"Regulation No. 64

Uniform provisions concerning the approval of vehicles with regard to their equipment which may include: a temporary-use spare unit, run-flat tyres ~~and/or a run-flat system~~

1. This document supersedes document GRRF/2015/12 and provides the consolidated text of UN R64 after extraction of the provisions related to TPMS. It includes the changes proposed per document GRRF-79-09.

Arrangements of approval marks

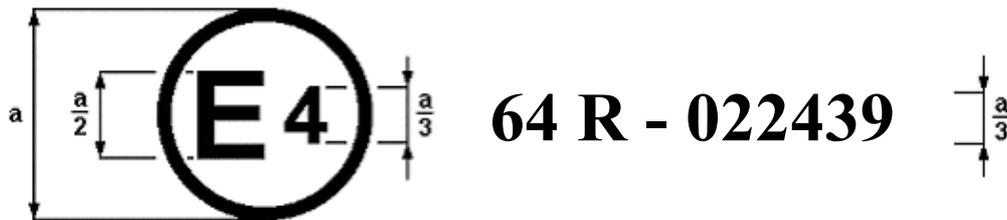
5. The examples of the approval mark in Annex 2 should not contain any reference to TPMS ("P") and the remaining examples should refer to the 03 Series of amendments.

The above approval mark affixed to a vehicle shows that the vehicle type concerned has, with regard to the equipment of temporary-use spare unit(s), been approved in the Netherlands (E 4), pursuant to Regulation No. 64 under approval number 022439. The approval number indicates that the approval was granted in accordance with the requirements of Regulation No. 64, incorporating the 02 series of amendments.
